FINAL PLAT
IDLE BANKS ADDITION
SEDGWICK COUNTY, KANSAS
2002

RE: SUB 2001-84 -- Final Plat of Idle Banks Addition

RE: SUB 2001-84 -- Final Plat of Idle Banks Addition

CASE NUMBER: SUB 2001-84 -- IDLE BANKS ADDITION**OWNER/APPLICANT:** Delbert I. and Elizabeth A. Wilson, 8942 N. Oliver, Wichita, KS 67147; Brian L. and Kristen C. Shelton, 127 N. Colby, Valley Center, 67147; Harvey E. And Bonnie J. Siemens, 7820 SW Huntoon, Topeka, KS 66615; James and Zelda Brownlee, 1930 W. Evanston, Valley Center, KS 67204;**SURVEYOR/ENGINEER:** Reiss and Goodness Engineers, Attn: Robert Previtera, 2160 W. 21st St., Wichita, KS 67203**LOCATION:** North of 85th St. North, East side of Oliver St.**SITE SIZE:** 60.88 Acres**NUMBER OF LOTS**

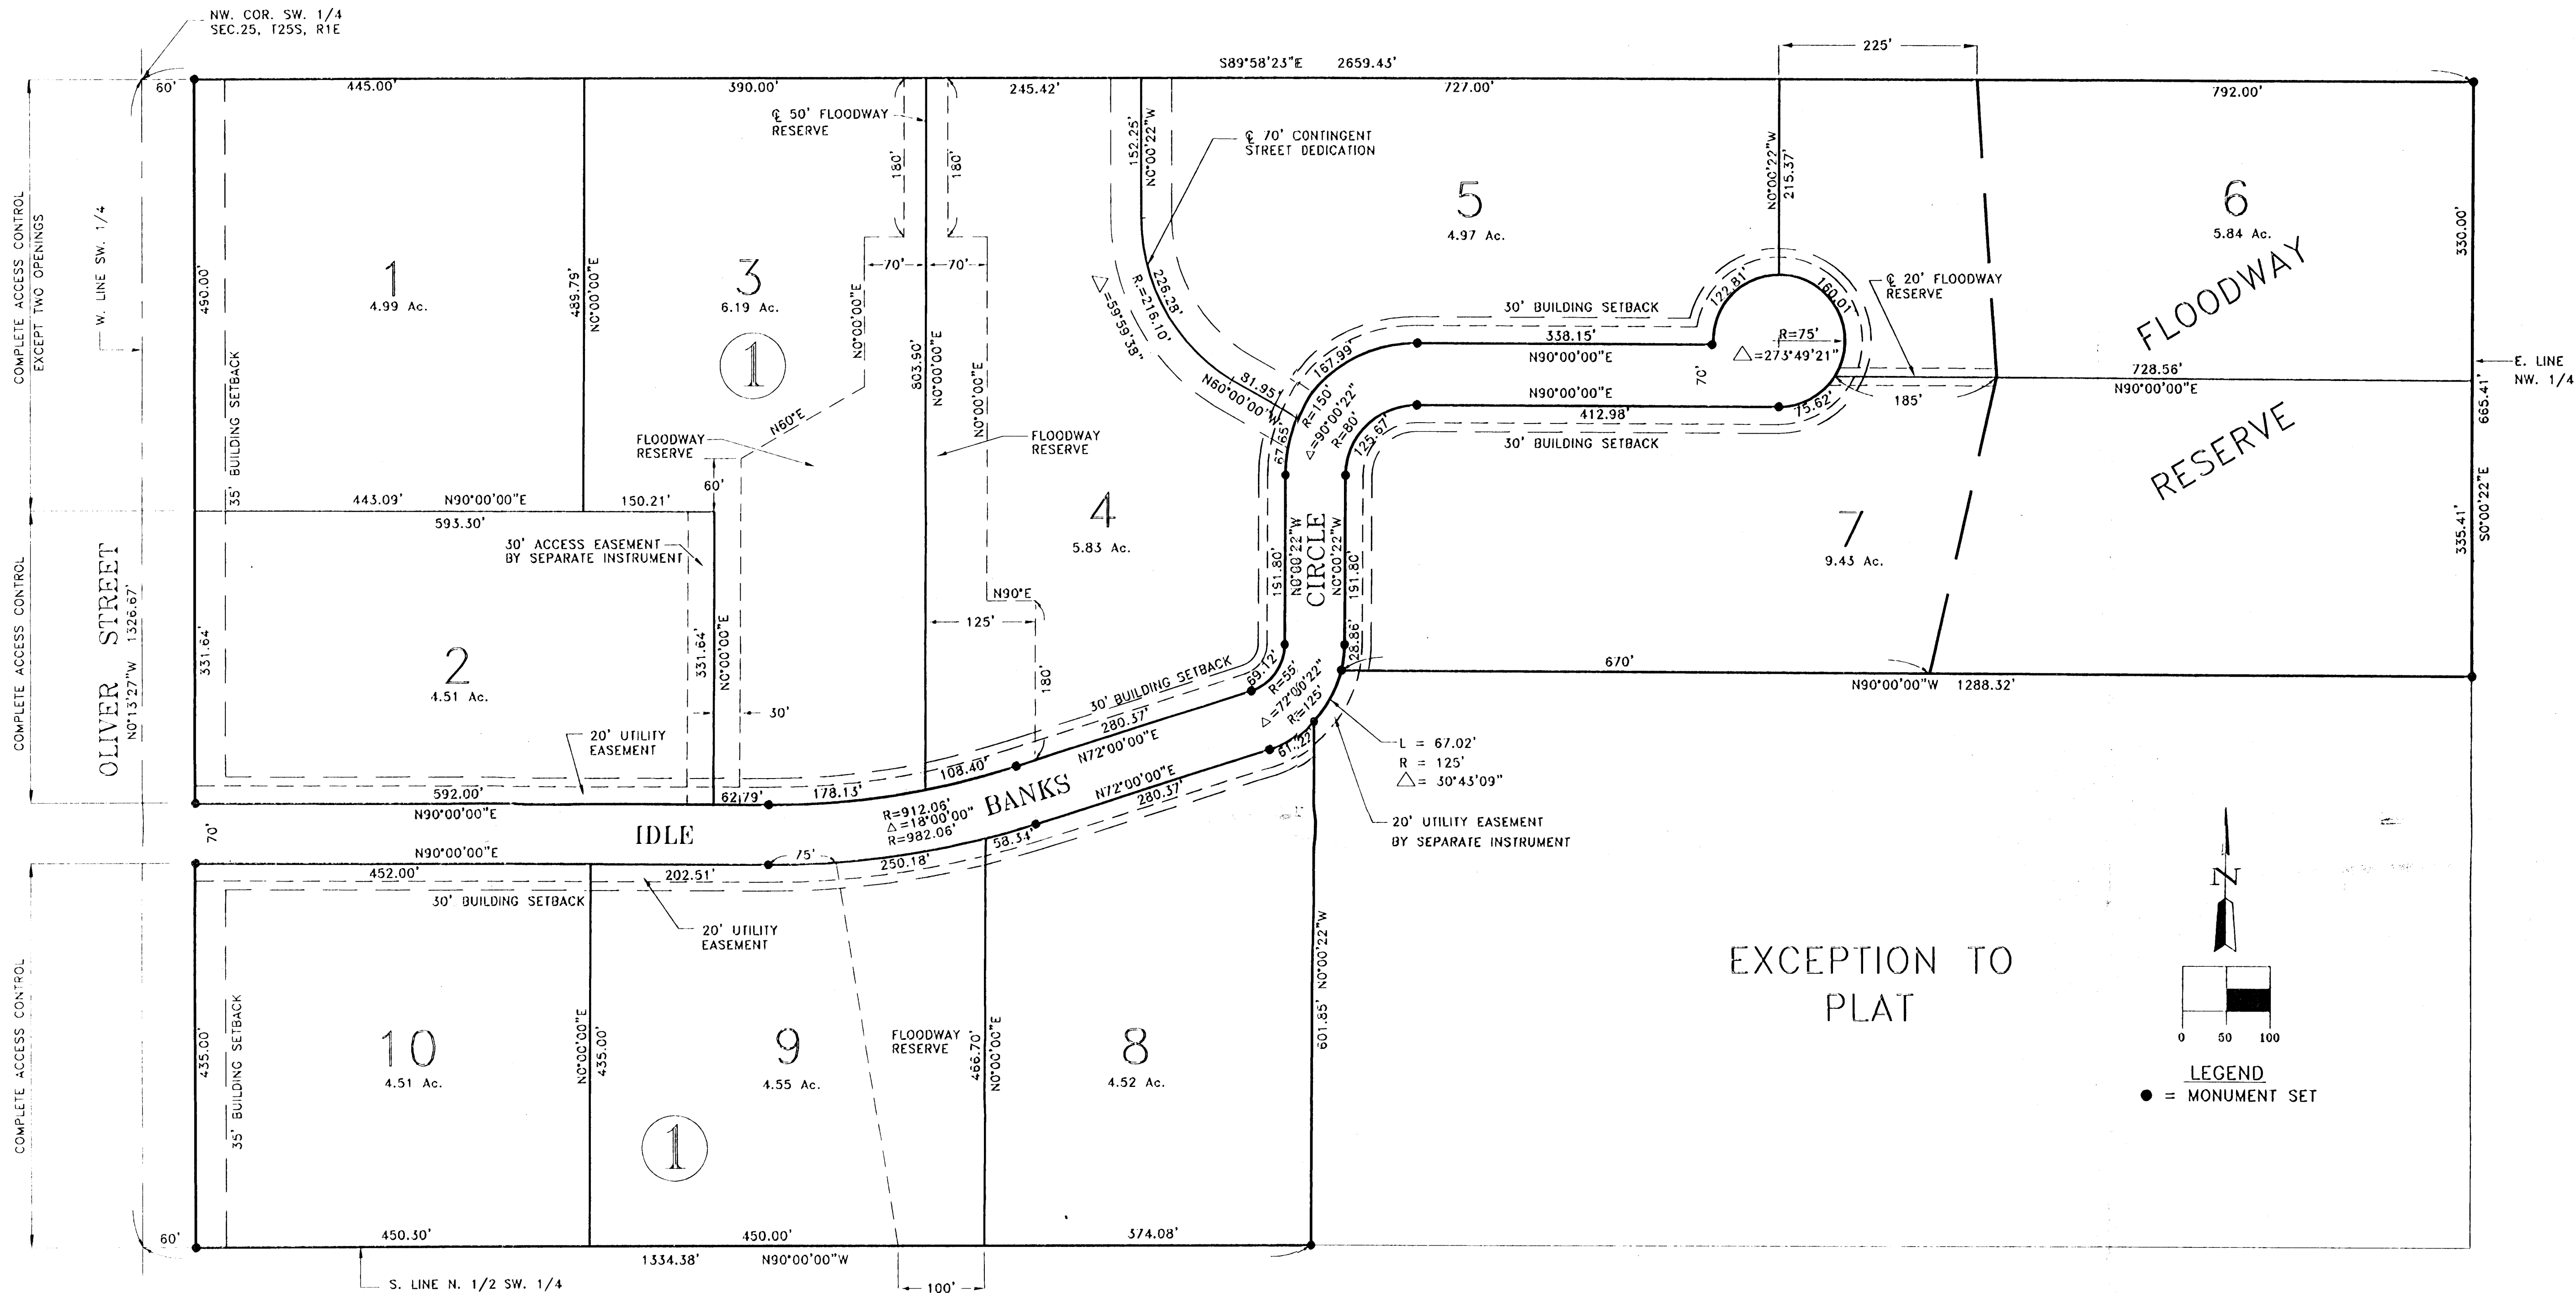
- A. Since neither municipal water nor sanitary sewer is available to serve this property, the applicant shall contact the Environmental Health Division of the Health Department to find out what tests may be necessary and what standards are to be met for approval of on-site sewerage facilities and water wells. A memorandum shall be obtained specifying approval. A layout denoting additional floodway reserve is needed for Lot 6 to determine buildable area. Soil testing is required.

- D. County Engineering needs to comment on the status of the applicant's drainage plan. County Engineering has advised that a HEC-2 computer run is required across Lots 6 and 7, and additional floodway reserve will be needed on Lot 6 as determined by the computer run. Minimum pads will need to be determined by the computer run. The drainage easements between Lots 3 & 4, between Lots 6 and 7, and between Lots 8 & 9, Block 1, need to be changed to Floodway reserves. A Master Lot grading plan is needed.

- H. The Applicant is advised that in regard to the structure on Lot 1 within the required 35-ft building setback, that while such areas of the existing structure may be retained, no enlargement of the building in such area will be permitted and if removed, all subsequent rebuilding shall observe building setbacks.

- I. Approval of this plat will require a waiver of the lot depth to width ratio of the Subdivision Regulations for Lot 3 and Lot 6. The Subdivision Regulations state that the maximum depth of all residential lots shall not exceed 2.5 times the width. *A modification has been approved by the Subdivision Committee.*

- J. The **County Fire Department/ GIS** needs to comment on the plat's street names. *The street names are approved.*
- K. The length of the internal street is approximately 2,200 feet exceeding the 1,200-ft limitation of the Subdivision Regulations. Approval of the plat will require a modification. **County Fire Department** recommends a modification due to the proposed connection to the adjoining property to the north. *The Subdivision Committee has approved a modification.*

- L. The Applicant has provided a pipeline easement agreement which appears to indicate a blanket easement for the area involved in this plat. The Applicant shall either obtain a release of this easement or provide proof that the easement has been confined. If confined, any portion of this easement impacting this site shall be denoted on the plat and shall be properly referenced. A recorded copy of the release/confinement of the easement shall be submitted.

- M. **County Surveying** has advised that the legal description needs to be corrected. "Section 25 South" needs to be revised to "Section 25, Township 25 South". The curve needs to be noted on the right or southeast side of the chord.

- N. The plat's text shall include language that a drainage plan has been developed for the plat and that all drainage easements, rights-of-way, or reserves shall remain at established grades or as modified with the approval of the applicable City or County Engineer, and unobstructed to allow for the conveyance of stormwater.
